SWIM PROJECT PROFILE		File No. : 136
Regist. No. : Agency No. : BSWM-47	Name: SAN MARCOS SWIP	
Region: 2	Province: QUIRINO	Municipality: CABARRQUIS
Present Status: 1. Pre-F/S() ② F/S(1985) ③ D/D(1985)		
Purpose: Major : Irrigation Incidental : IF, FC, WM		
Project Feature:

SWIM PROJECT PROFILE		File No. : 137
Regist. No. : Agency No. : BSWM-48	Name : SAN FRANCISCO SWIP	
Region : 2	Province : QUIRINO	Municipality : AGLIPAY
Present Status: 1. Pre-F/S() (2) F/S(1985) (3) D/D(1985)		
Purpose: Major : Irrigation Incidental : IF, FC, WM		
Project Feature:

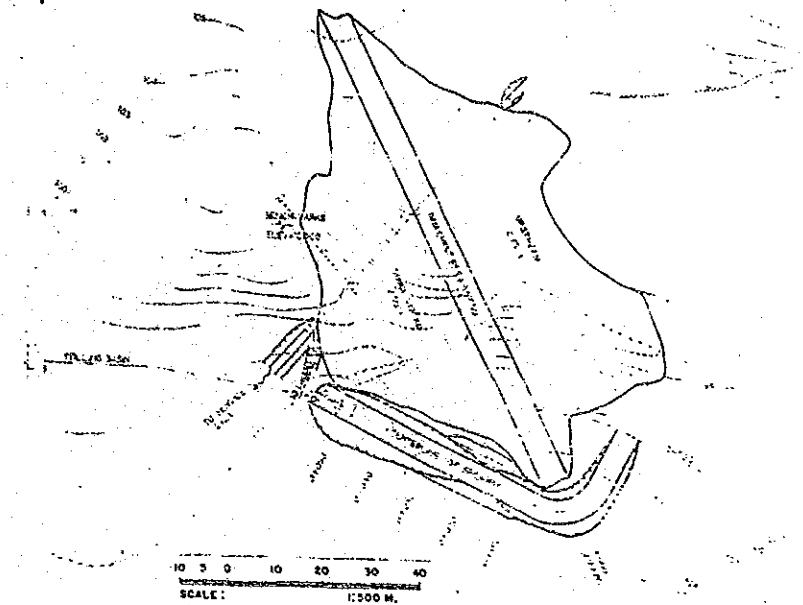
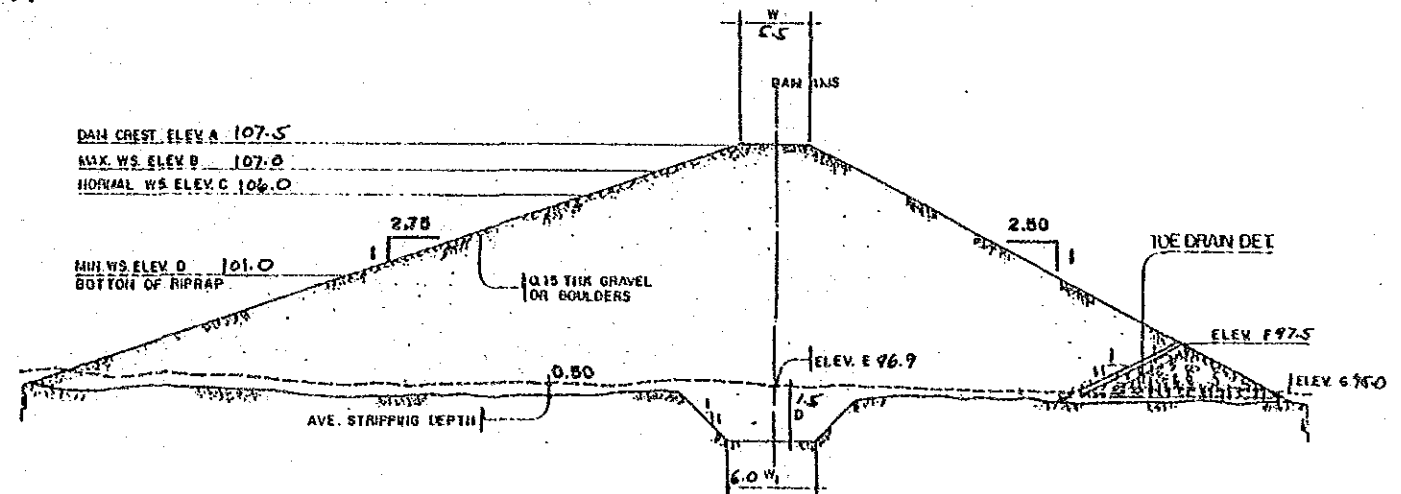
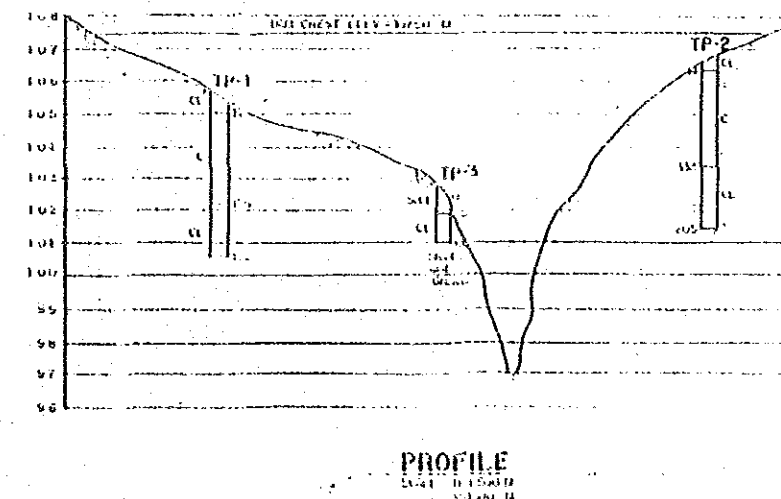
2. Planning Environmental conservation plan is not formulated.		
3. Design Depth of core trench shall be modified during construction. Stability of upstream slope of the dam shall be checked. Weir shall be provided in the spillway. Center line of the spillway shall be shifted to left side.

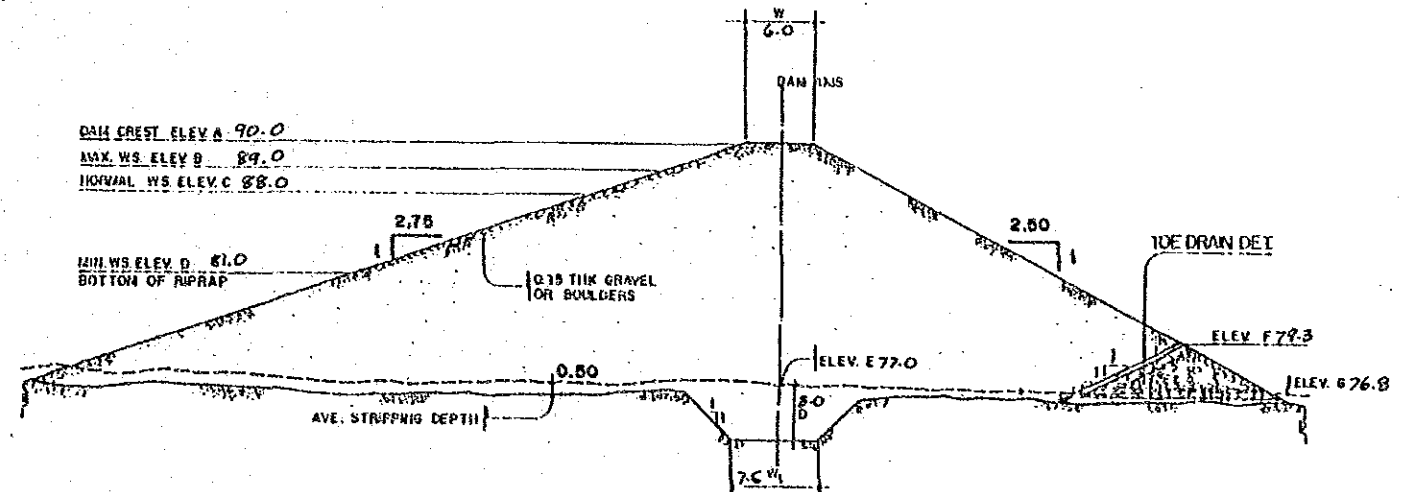
2. Planning Environmental conservation plan is not formulated.		
3. Design Depth of core trench shall be modified during construction. Stability of upstream slope of the dam shall be checked. Freeboard is not enough. Weir shall be provided in the spillway. Center line of the spillway shall be shifted to left side.

Silty clay with 3.0 m depth is piled up on the sand stone and shale. Additional 0.5 m freeboard is necessary.

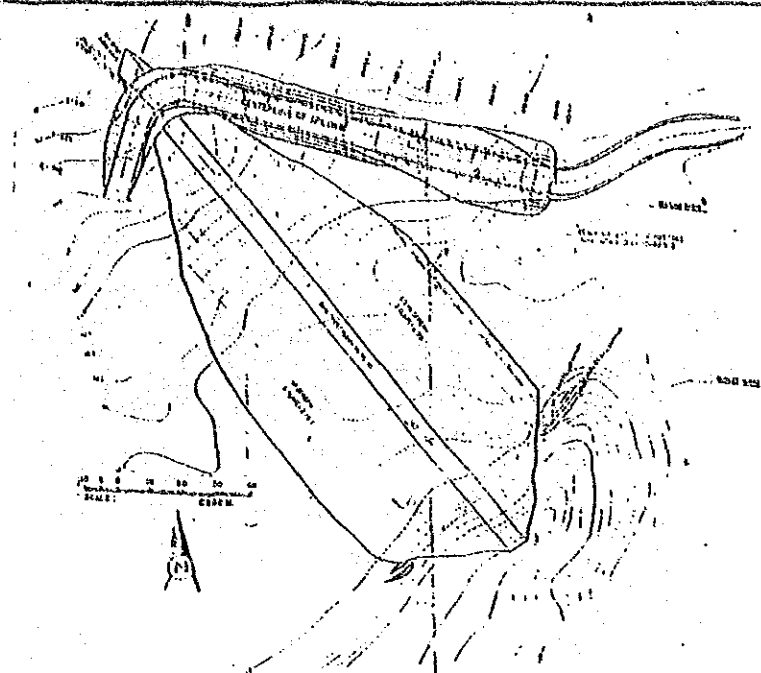
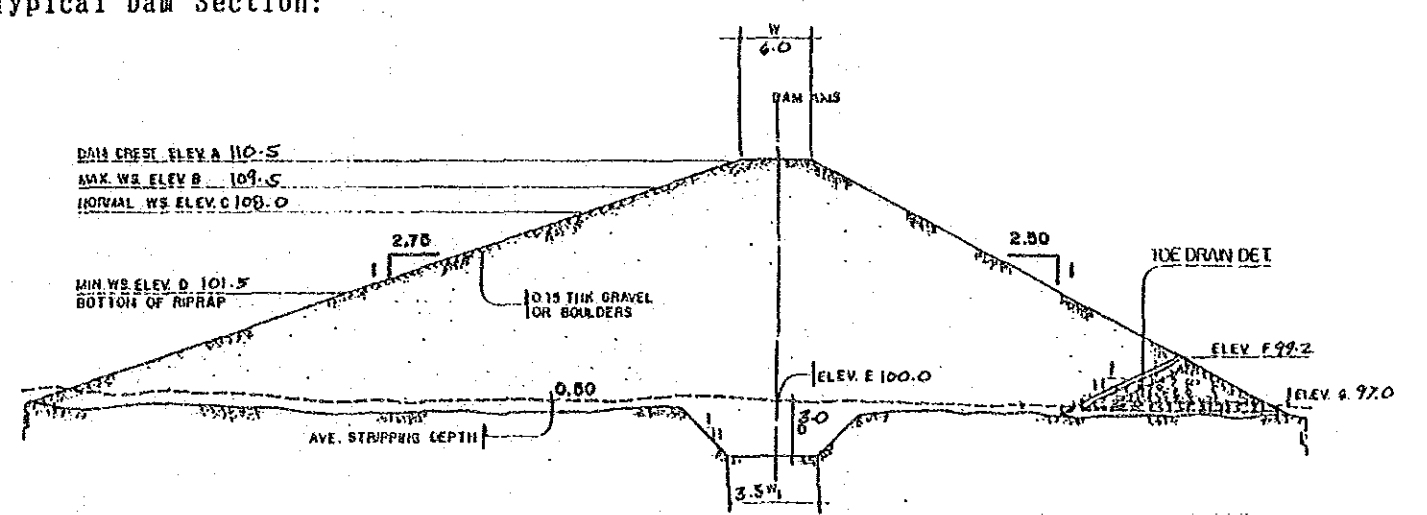
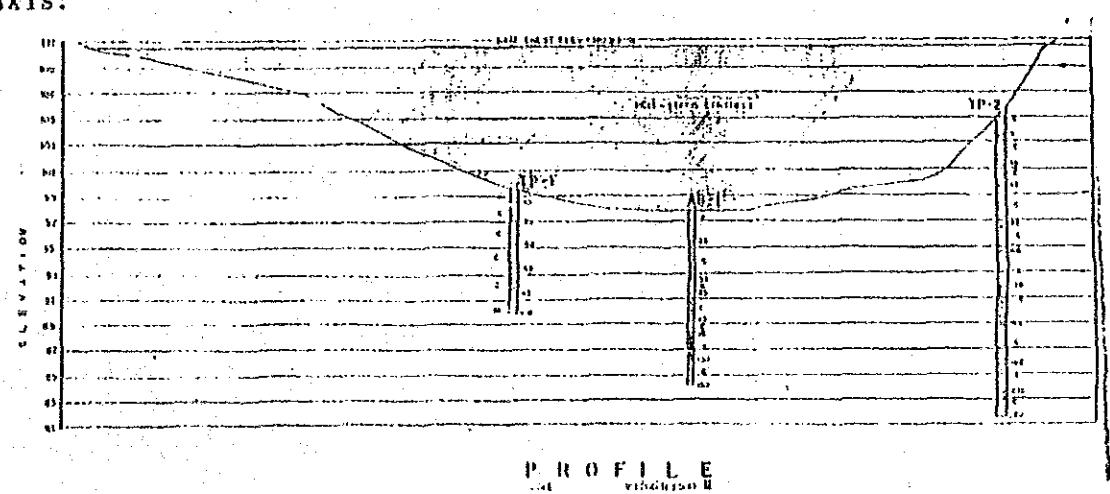
2. Planning Environmental conservation plan is not formulated.		
3. Design Depth of core trench shall be modified during construction. Stability of upstream slope of the dam shall be checked. Weir shall be provided in the spillway. Center line of the spillway shall be shifted to left side.

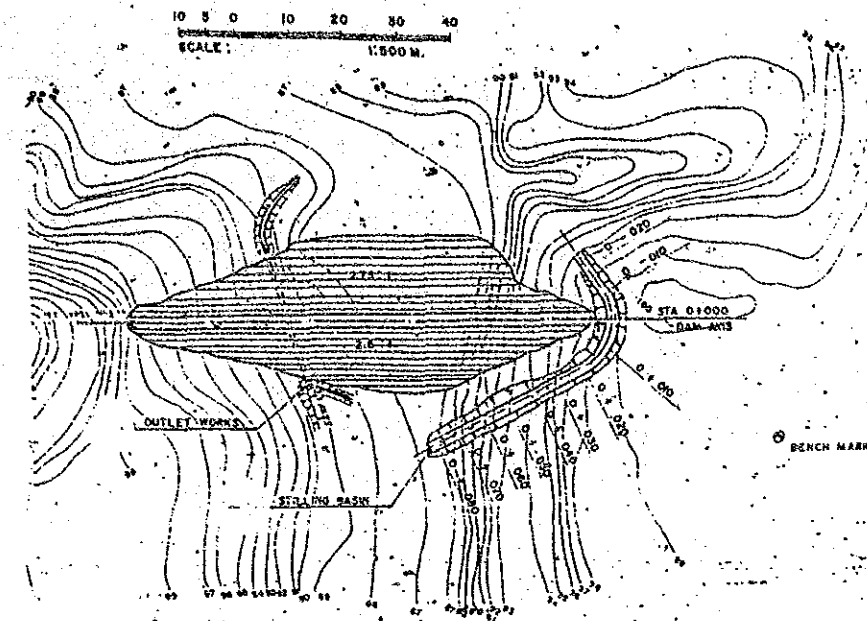
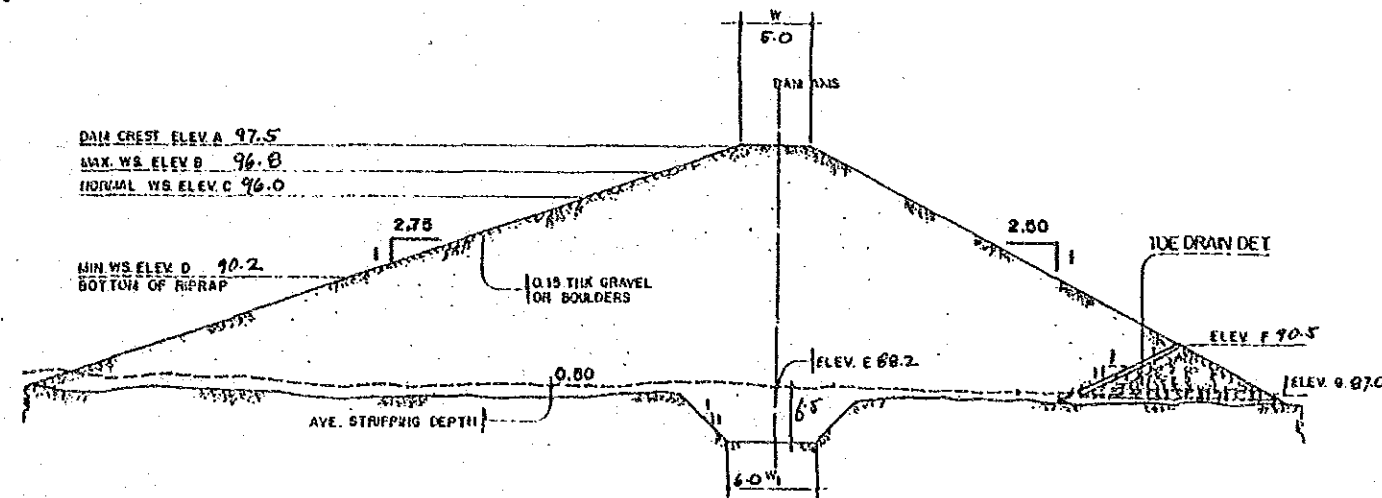
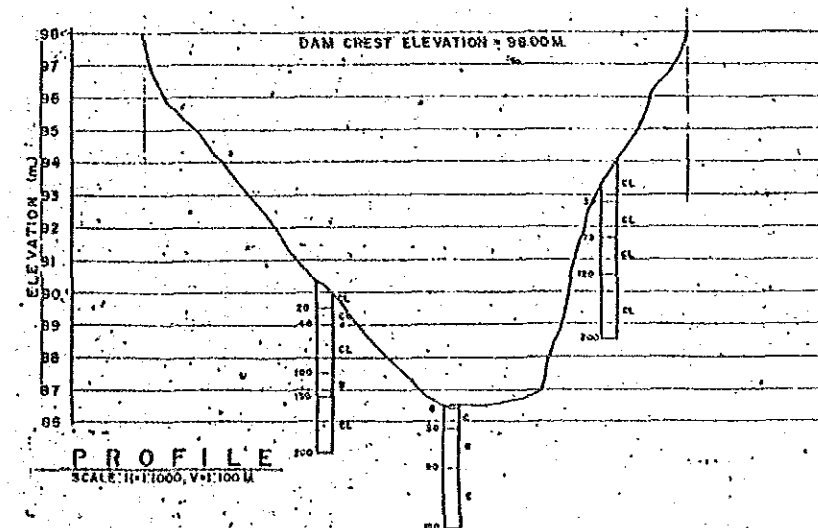
2. Planning Environmental conservation plan is not formulated.		
3. Design Depth of core trench shall be modified during construction. Stability of upstream slope of the dam shall be checked. Freeboard is not enough. Weir shall be provided in the spillway.

Terrace gravel underlies clay blanket with 2.0 m depth. Investigation on the clay distribution as natural blanket shall be carried out. Additional 1.0 m freeboard is necessary.

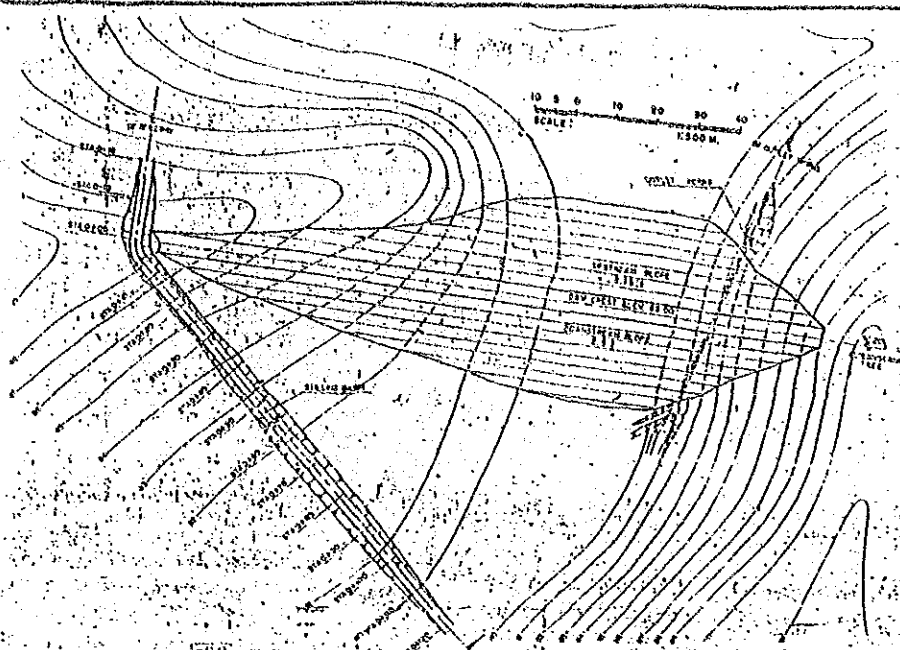
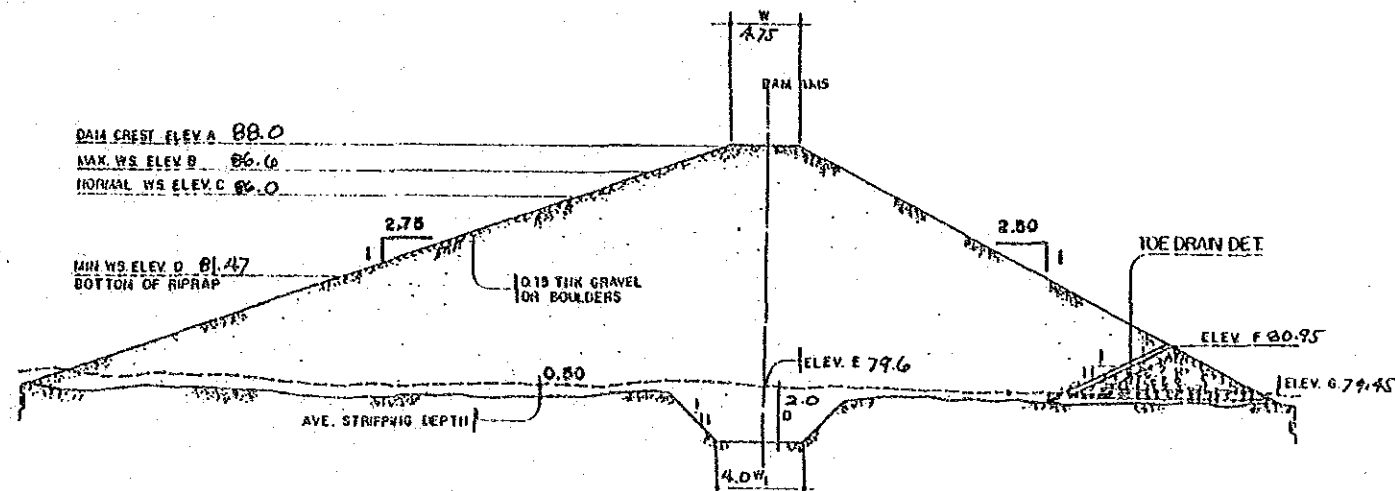
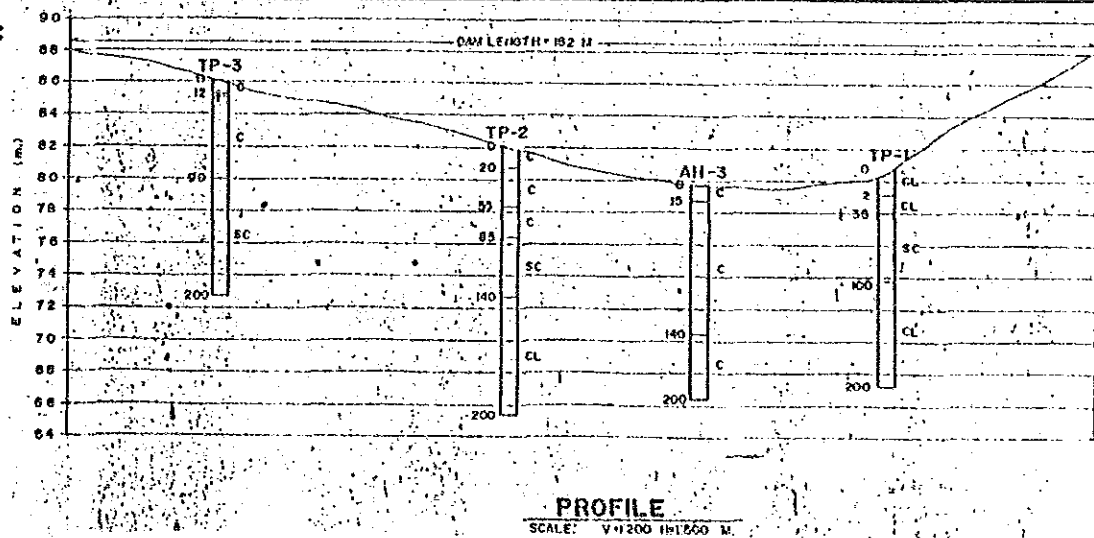
2. Planning Environmental conservation plan is not formulated.		
3. Design Countermeasure for seepage shall be planned. Stability of upstream slope of the dam shall be checked. Weir shall be provided in the spillway.

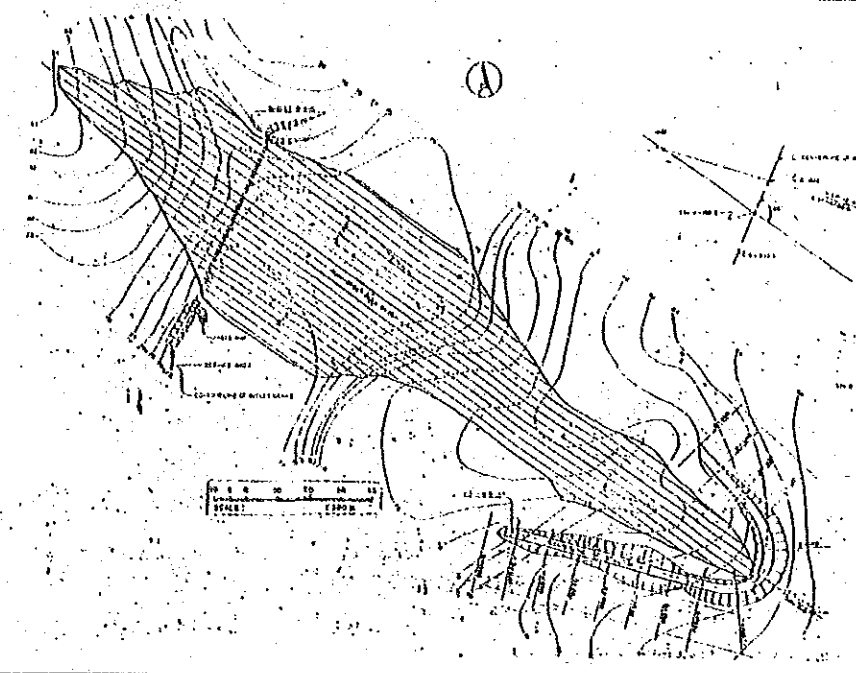
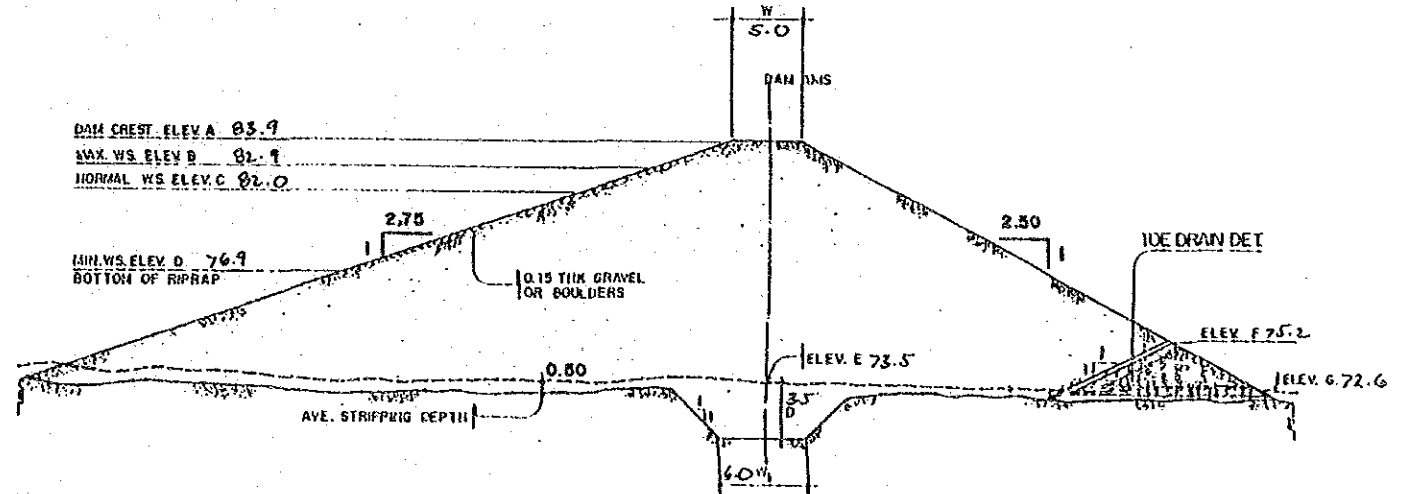
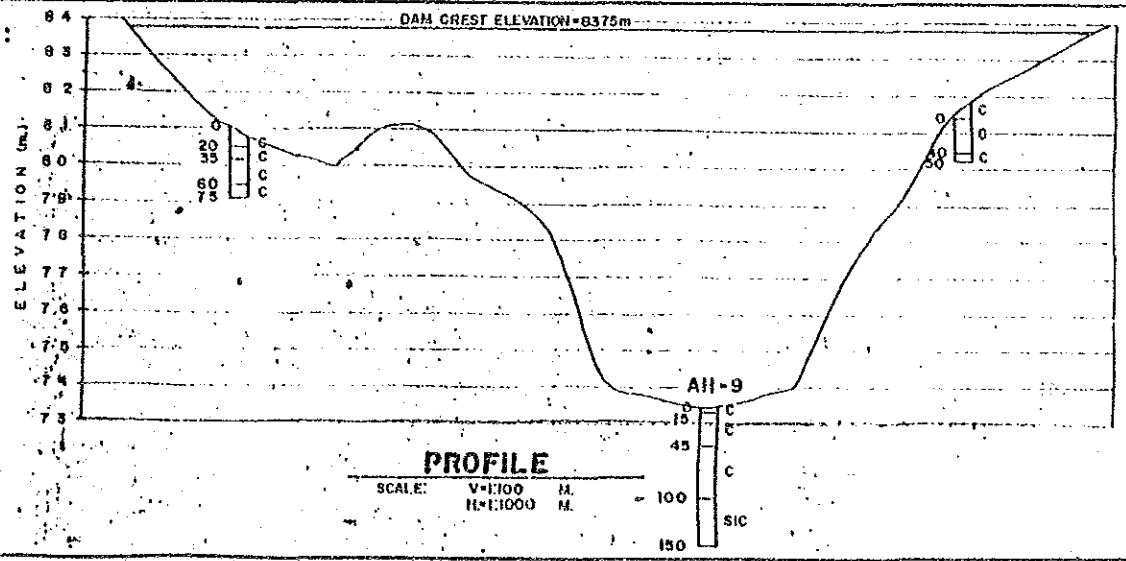
2. Planning Environmental conservation plan is not formulated.		
3. Design Countermeasure for seepage shall be planned. Stability of upstream slope of the dam shall be checked. Weir shall be provided in the spillway. Center line of the spillway shall be shifted to left side.

Note: Conglomerate, of which matrix is coarse-grained and calcareous sandy, underlies top soil with 0.5 m. Seepage through foundation shall be noticed. Additional 0.5 m freeboard is necessary.
